Council Reference: DA11/0565  
Your Reference: MP08\_0194 Mod 3

**Proposed modification application to amend MP08\_0194 as it relates to Kings Forest Precinct 1 Service Station and Food & Drinks Premises**

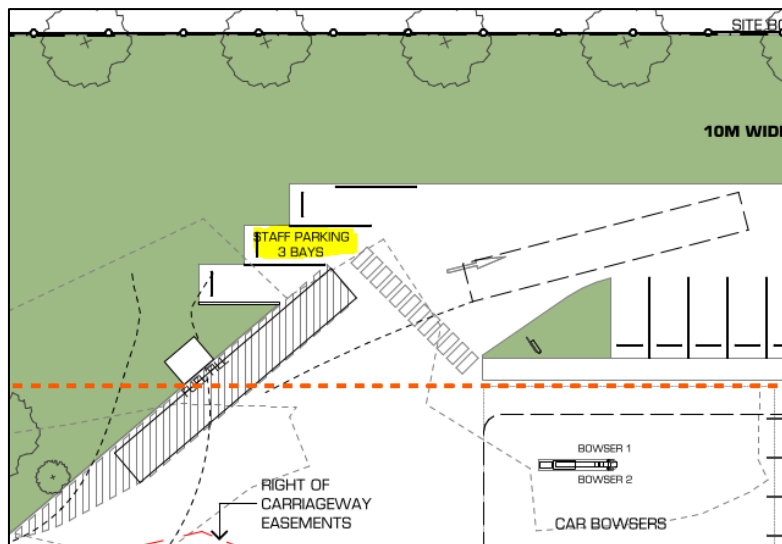
- Any modified application should be accompanied by an updated bushfire management plan given that the bushfire mapping was updated in May 2023.
- Condition 105 requires that *'the number of car spaces, bicycle spaces and loading bays to be provided for the service station/food and drink premises development in Precinct 1 must comply with the requirements of Section A2 – Site Access and Parking Code of the Tweed Shire Council Development Control Plan 2008 (as in force at the date of this approval).'* As such any modification application should include an assessment against DCP A2.

- The application should confirm that the amended layout can comply Condition 106 which requires
  - *Car parking associated with the proposal (including queuing areas, grades, turn paths, sight distance requirements, aisle widths, and parking bays) must be in accordance with AS 2890.1-2004 and AS 2890.2-2002 for heavy vehicle usage.*
  - *The swept path of the longest vehicle (including garbage trucks and fuel delivery trucks) entering and exiting the site, as well as manoeuvrability through the site, must be in accordance with AUSTRROADS.*
  - *A revised pedestrian movement and access plan which details the interaction between vehicles and pedestrians must be prepared in accordance with the relevant Australian Standards.*

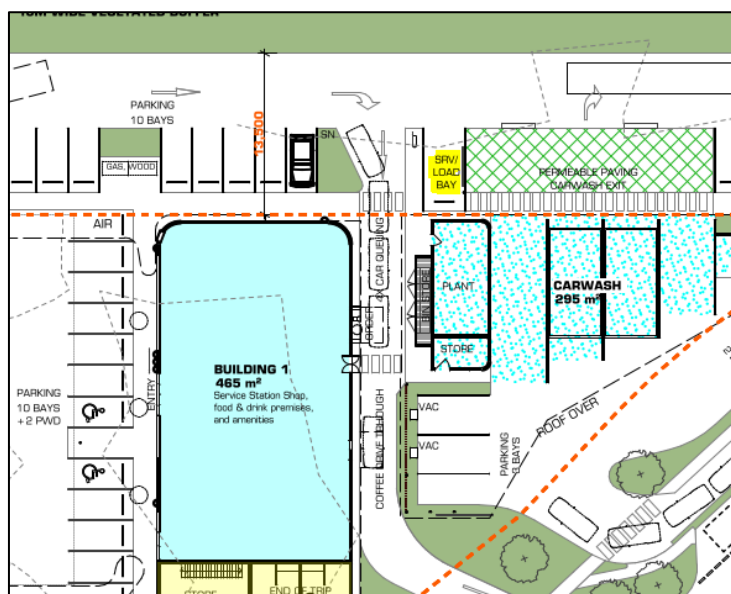
- **Staff carparking** - It appears that only 3 Staff car parks are proposed - Refer to Condition 105 for the required car parking numbers. Three spaces would appear to be an under-supply.

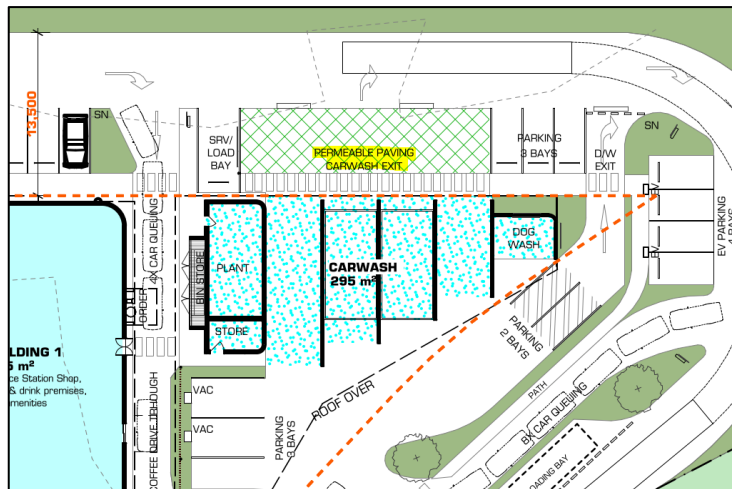
- **SRV loading bay** - The proposed amended SRV/loading bay is significantly smaller than the previously approved SRV/loading bay. It is also in an isolated location and the question is raised as to what it is servicing. It appears that it will then require servicing from the bay by use of the pedestrian footpaths - Potential conflict of use?

- **Proposed Permeable Paving Car Wash Exit** - It appears that the intent is for users of the car wash to drive over the pedestrian footpath and then over the permeable pavers to exit.
  - Potential pedestrian safety concerns / conflict of use.
    - Appears that sight line triangles (no different to a driveway) are not provided for existing vehicles from the car wash bays.
  - Permeable Pavers effectiveness deteriorate unless maintenance is maintained.

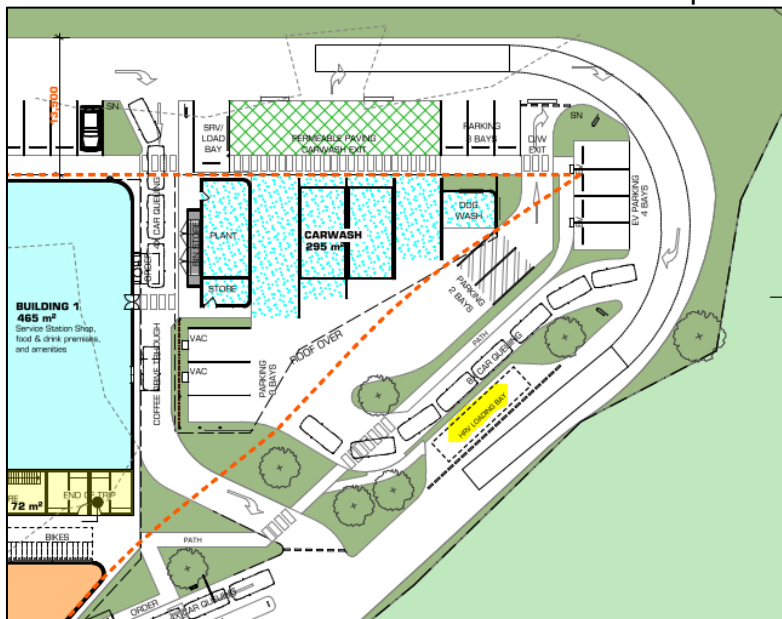
- **2 parking Bays in Car Wash area**
  - The use of these 2 car parks will impact of vehicles exiting the car wash areas, if they not using the car wash bays (i.e. users of the VAC areas).
  - They appear to be in an inappropriate location.
- **Proposed, amended HRV Loading bay**
  - Similar to the SRV (above), the proposed HRV bay is in an isolated location and the question is raised as to what it is servicing.
  - How would the HRV be unloaded and not impact on exiting vehicles?

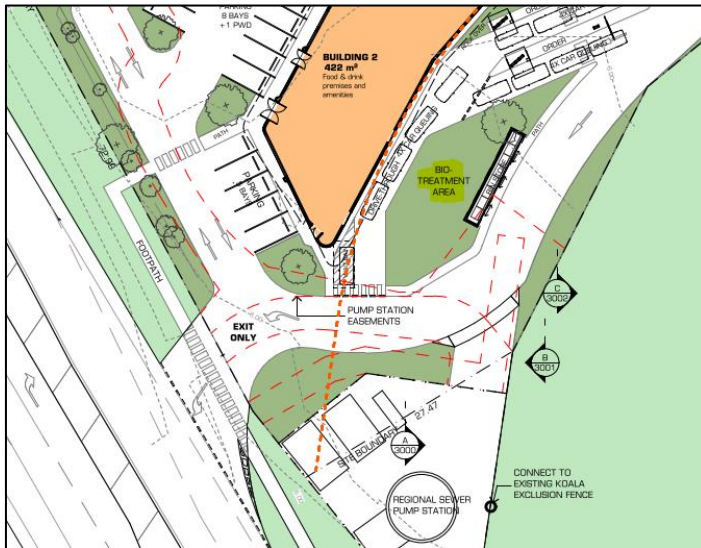
- **Bio Treatment Area**
  - **Condition 111** specifies that the peak stormwater flow rate that may be discharged from the site to the public realm in events of intensity up to the ARI 100 year design storm must be no greater than predevelopment.
  - No details have been provided as to the proposed configuration of the internal pipe network and it's intended Legal Point/s of Discharge (piped and overland flow).
  - Where does the major overland flow discharge?

- The modification should include details of the proposed pipes and outlets, and how the bio-basin discharges,

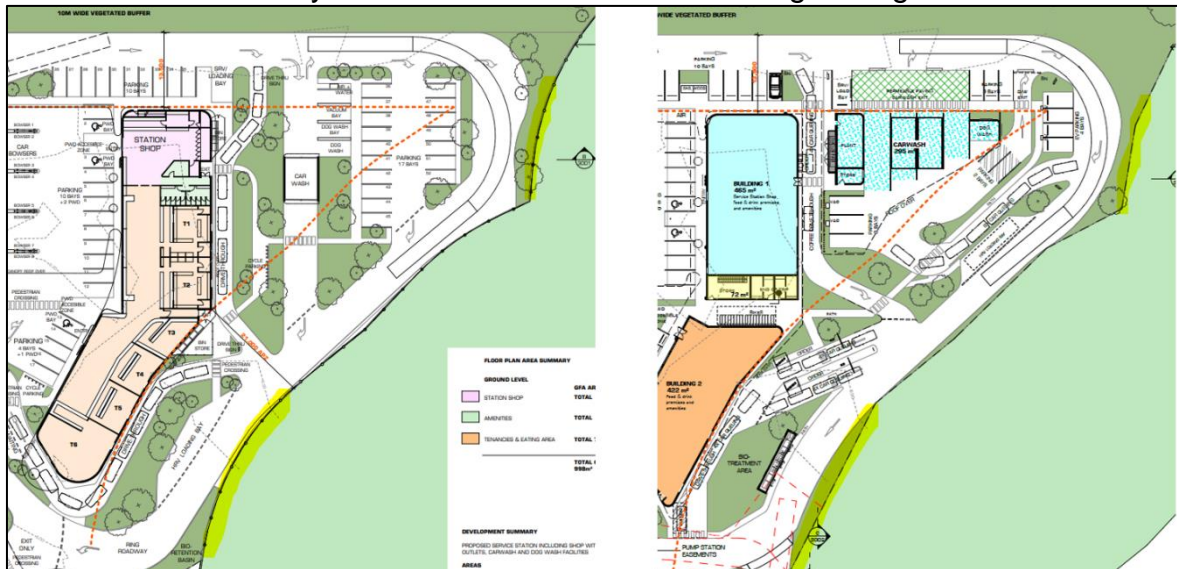
- Maintain the approved ecological buffer:** The updated plans show a realignment of the fauna fence along the ecological buffer. It appears to show a slight reduction to the ecological buffer from the approved plans (see yellow highlights below) however the revised plans also appear to align with the current property boundary. Given this is only a concept plan it is difficult to confirm any encroachment, however it is recommended any modification maintain the existing ecological buffer.
